DENDROBIUM AREA 3C LONGWALL 20-21 SUBSIDENCE MANAGEMENT PLAN Reasons for Approval

Fig 2: Location of Longwalls 21 and 20.

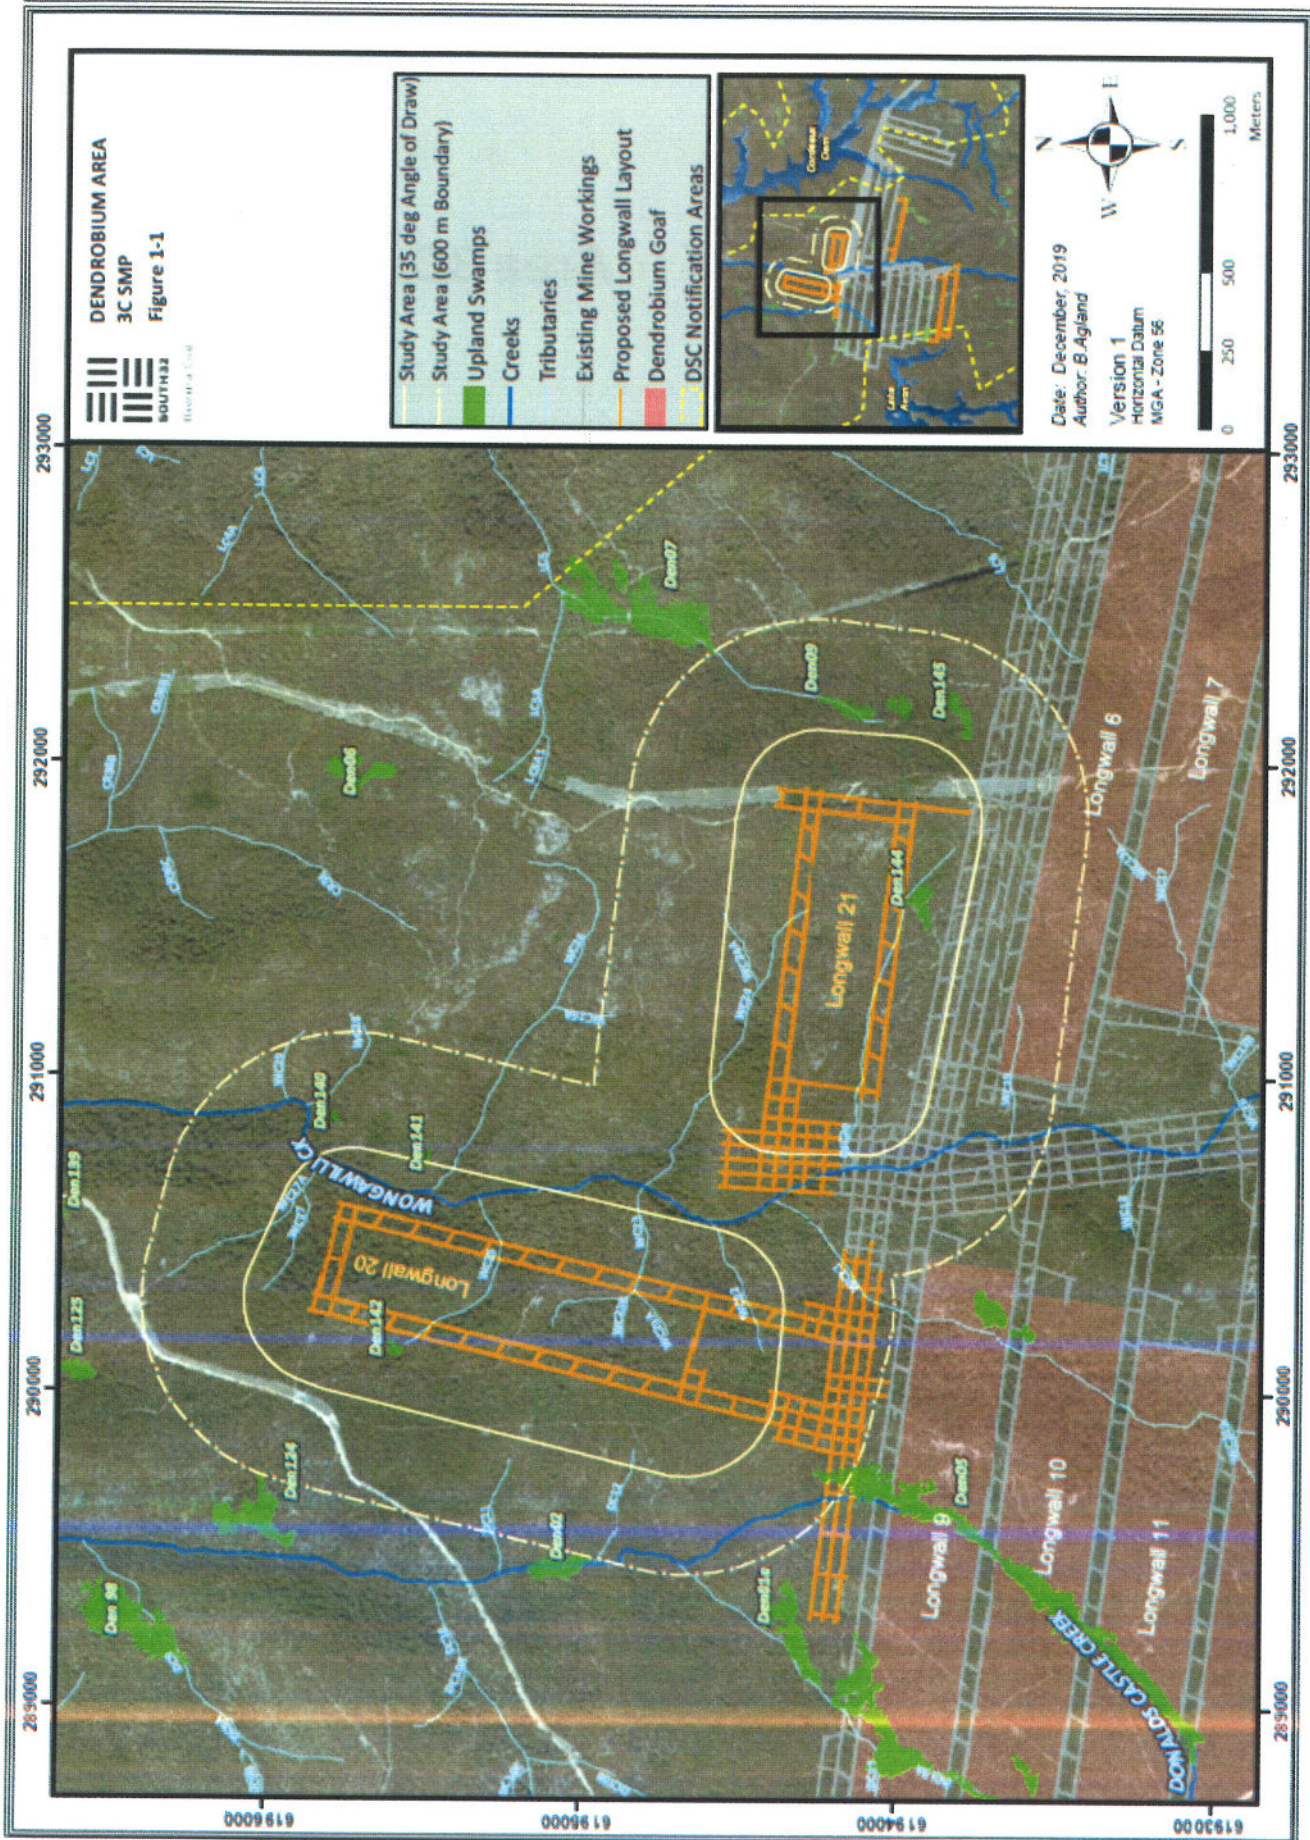
- The key differences between the two longwalls include the:
 - proposed orientation of Longwall 20 is roughly parallel to Wongawilli Creek, which substantially increases the length of the creek which may be subject to valley closure, surface cracking and the area of its catchment that may be subject to groundwater depressurisation (and therefore baseflow reduction) and at the same time reduces adaptive management options;

- centreline of Wongawilli Creek is just 125 m east of the tailgate of Longwall 20 but 240 m west of the finishing end of Longwall 21, at the closest points to the proposed total longwall voids. The closer proximity increases the predicted valley closure; and

- proposed extraction of Longwall 21 is from east to west, which allows for adaptive management through shortening the longwall ("pulling up short") should subsidence effects in Wongawilli Creek exceed permitted levels.

- For these reasons, advice received from WaterNSW focussed on issues relating to Longwall 20. PAG agrees with this position and considers that Longwall 21 has substantially fewer associated risks.

- At the present time, some doubt exists as to whether both of these performance measures can be met if Longwall 20 is extracted as proposed and PAG has therefore sought further information from South32. However, PAG is satisfied that Longwall 21 can be extracted, as proposed under the SMP, with a low risk of exceedance of either of these two performance measures, particularly if the Panel's advice is applied.
